PLANNING & DEVELOPMENT CITY OF NEWARK

July 5, 2022

The City of Newark's Subdivision Advisory Committee has reviewed the May 3, 2022 submission for the major subdivision plan for the proposed Hilton hotel at 1119 South College Avenue (PR#22-01-01). We have the following comments:

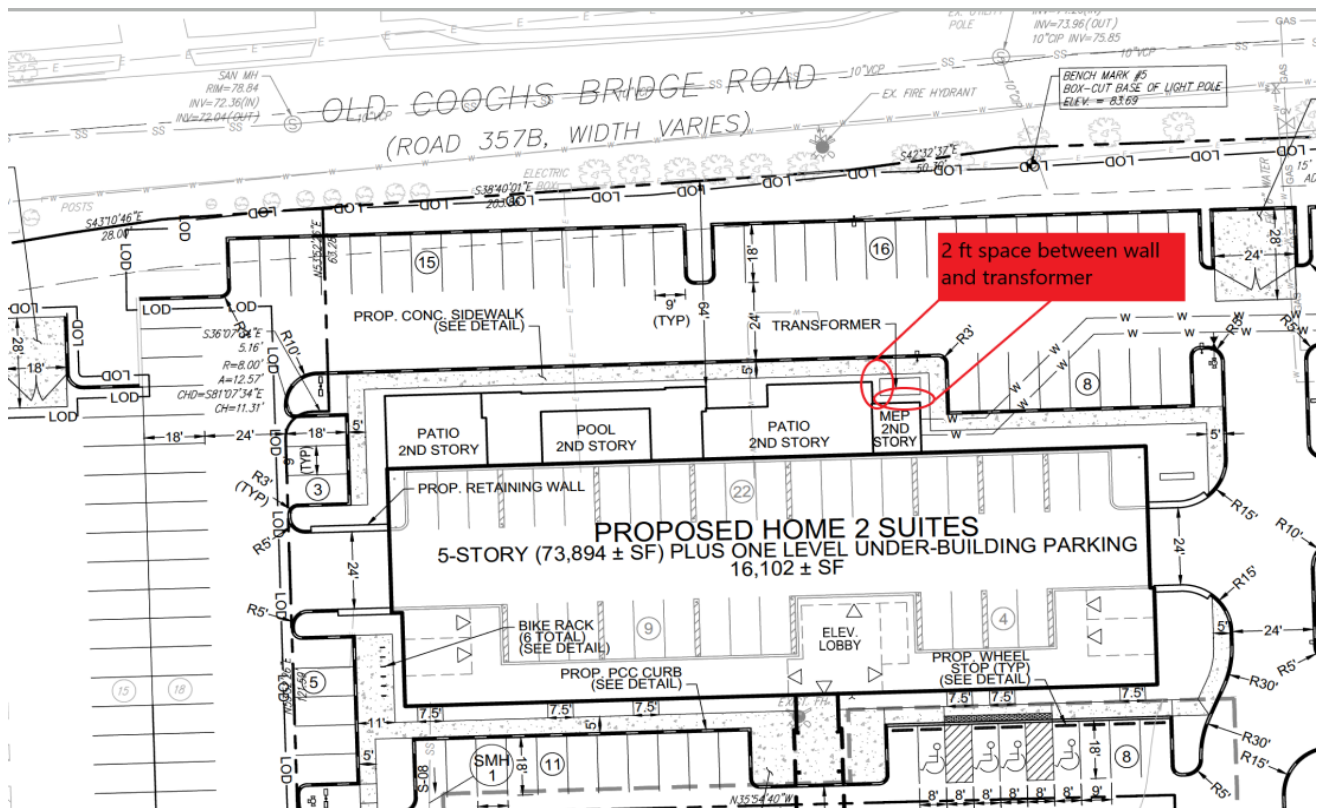
1. The existing utility pole 46E25 and 3-phase aerial lines must be surveyed and shown on the print.

- Any oil-filled pad-mounted equipment shall be located a minimum of 10' from combustible buildings, windows, doors, and stairwells.

The proposed transformer location does not meet this requirement. The developer must contact the electric department to review the transformer location and underground conduit run.

- Note #21 on sheet 1 – should read, The proposed transformer will feed the hotel and has a limit of six (6) conductors per phase. If more than six (6) conductors are necessary, the developer must install a transition box at their cost.
- A separate transformer will be installed for future commercial pad site. A suitable location approved by the Electric Department will be required for a pad-mounted transformer for future commercial pad site.
- No part of the building can be closer than 12.5 feet to the power lines.
